RADIANT
HEATING SYSTEMS
THERMAL ZONE VALVE

SELL SHEET

Uponor Thermal Zone Valve

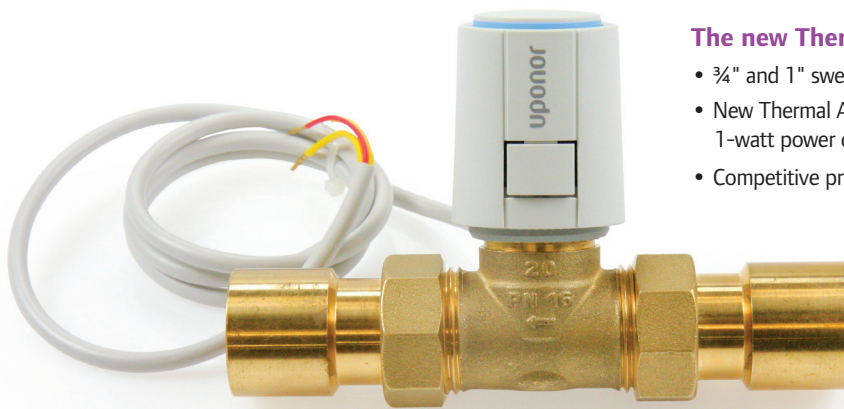
Uponor is now offering a new Thermal Zone Valve, four-wire (A3011075) which will replace the 3/4" Thermal Zone Valve, four-wire (A3010525) and 1" Thermal Zone Valve, four-wire (A3010526).

The new Thermal Zone Valve (A3011075) includes:

- 3/4" and 1" sweat adapters
- New Thermal Actuator, four-wire (A3023522) with lower, 1-watt power consumption
- Competitive pricing
